**Project: IEEE P802.15 Working Group for Wireless Personal Area Networks
(WPANs)**

Submission Title: comment resolution assignment

Abstract: proposes comment resolutions for a set of CIDs

Figure 23: Two Part Preamble

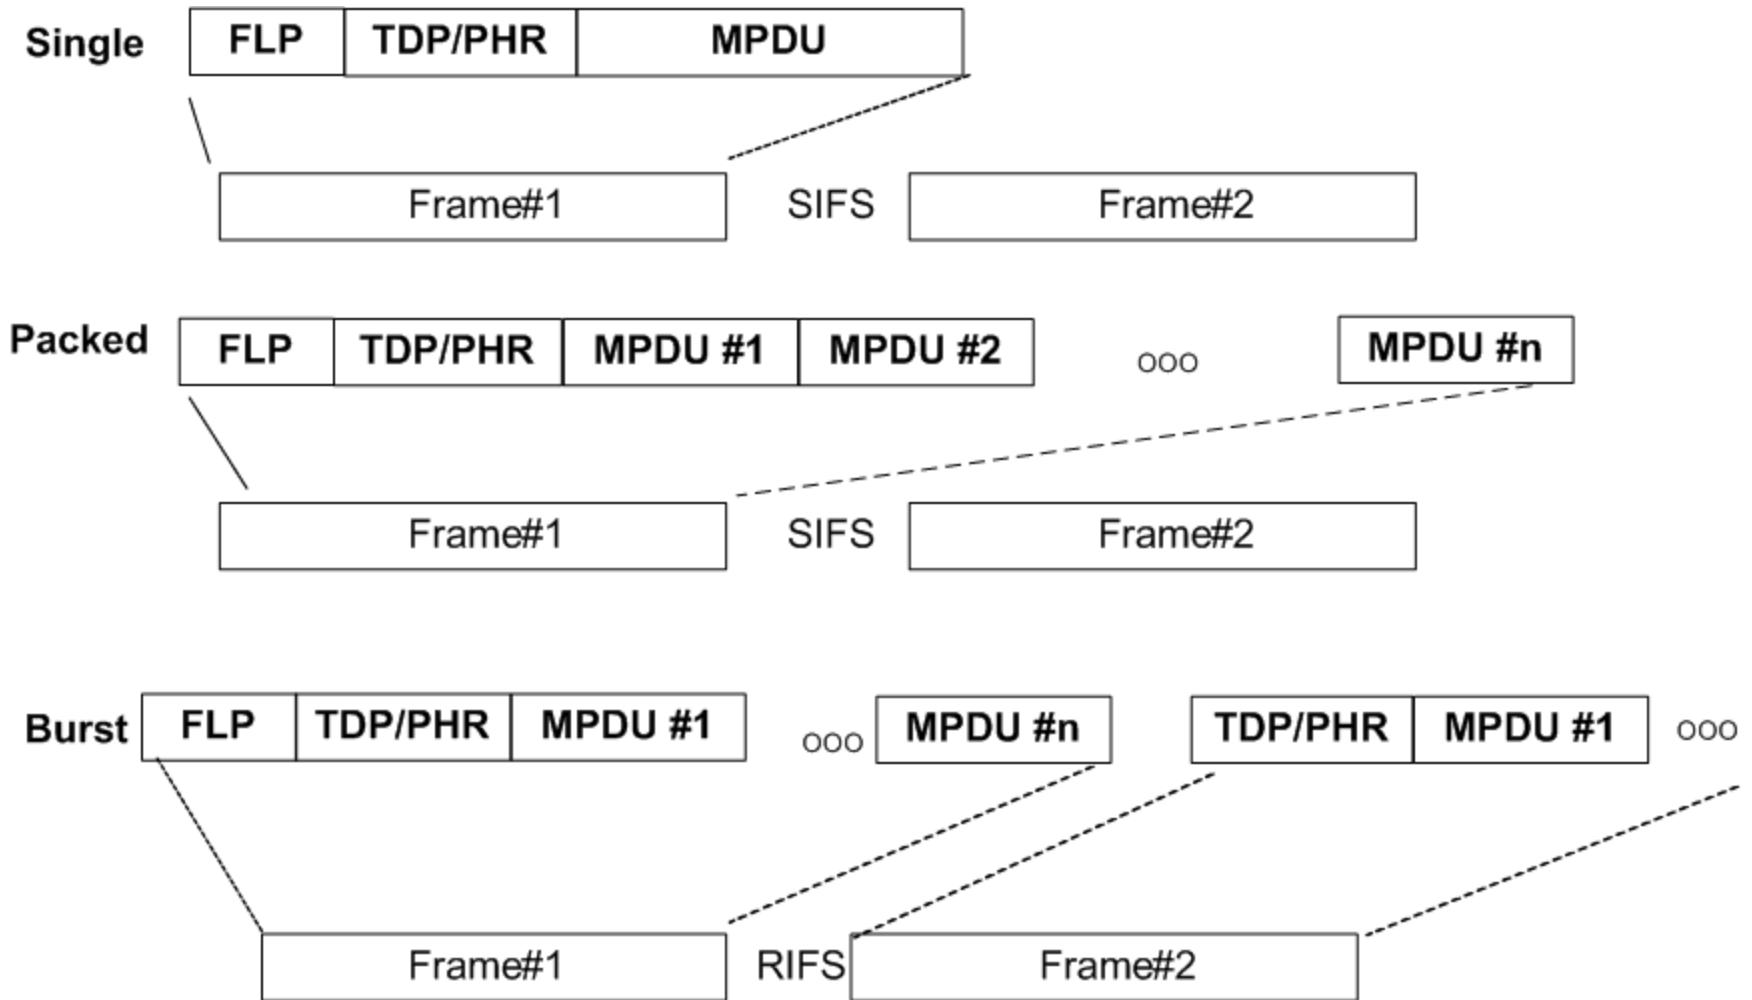
- In Figure 20, in Burst mode, there are two MAC PDU #n. These should be fixed.
- Figure 20 - Burst Mode - shows the same MAC PDU being transmitted twice, in both Frame #1 and #2. This figure does not align with the text
- (SY) In Burst mode, both packets are shown with the label "MAC PDU #n". I believe that the labels should be different

- Comment accepted in principle. However, fix is not easy.

Instruction to editor: Update Figure 23

Update Page 39, line 40 as follows:

- The standard defines one fast locking pattern (FLP) followed by choice of 4 topology dependent preamble (TDP) repetitions for the purposes of distinguishing different PHY topologies.

Update Page 39, line 46 as follows:

- After the fast locking pattern, 4 repetitions of one of four TDPs are sent.
